SUPPLY AND INSTALLATION OF REPLACEMENT LIGHTING AT HOTEL ROANOKE AND CONFERENCE CENTER

Subject: Official Communication #1 and Official Addendum #1 and #2

Subject: Official Communication 2

Subject: Official Addendum #3 (Extension of due date for sealed bids) for the Lighting Project at The Hotel Roanoke & Conference Center

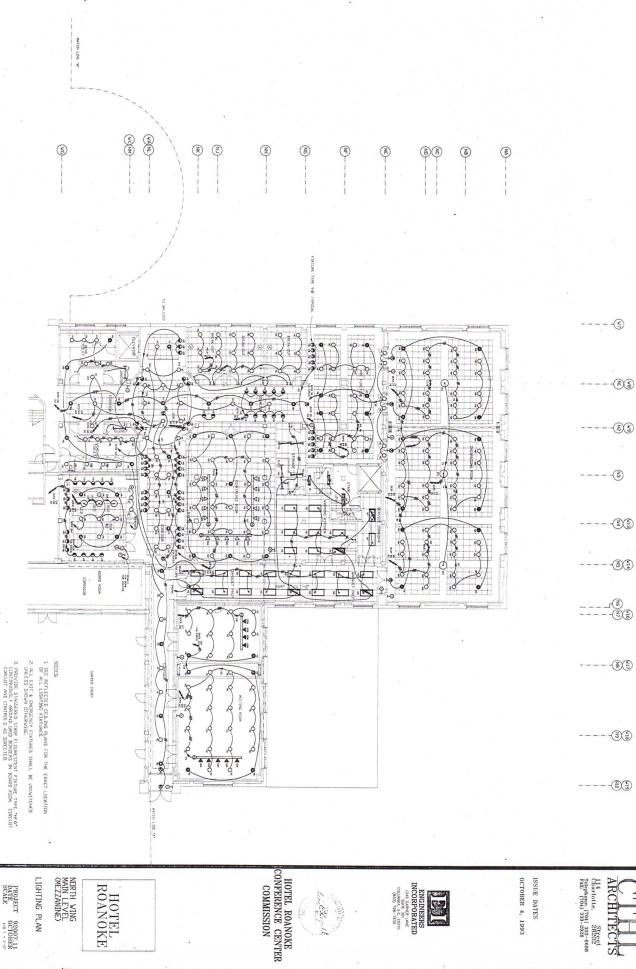
- 1) Areas of Work -
- a. In many of the areas shown in orange on the layout map there are fixtures in gypsum ceilings in addition to the ACT. Are the lights in gypsum intended to be replaced as well? Yes
- i. If yes, the existing fixtures likely contain large housings above the ceiling. Are these required to be removed from the building, or can be left "abandoned" above the ceiling? Due to limited access to above, removal will require cut and patch of the gypsum ceiling at many fixture locations. Leaving the old disconnected fixture-housing in the ceiling is fine as long as it is done safely and is with-in code.
- ii. If yes, the new light fixtures cannot be guaranteed to cover all existing paint lines from the old fixtures. Should full painting of all bulkheads be included in these areas to provide a quality finished appearance?

- iii. The round conference "atrium" with stairs that leads from upper to lower levels is not colored on the map to be included. There are numerous fixtures in this area in gypsum ceilings. Are they to be included? Yes

- b. The "Peacock Alley" and "Pocahontas" rooms are shown to be part of the scope and currently has only gypsum ceiling with no known access to above. This will likely require cutting and patching at each light fixture and subsequent painting of the entire ceiling. Can you confirm this is what is desired? Yes

- c. The Appalachian room is shown colored yellow on the map (to be included), but during our walkthrough it was noted that this room has already been remodeled. Should it be included in this project? No, Since this room is already stand-alone, It should be left out of the project. This room was color coded on the map mistakenly.

- d. The orange areas show alternate add for new fixtures, but it does not specifically list controls in these areas. As the new fixtures will not function with the existing controls, can you confirm that new controls should be included in these locations too? Yes

Yes, if needed
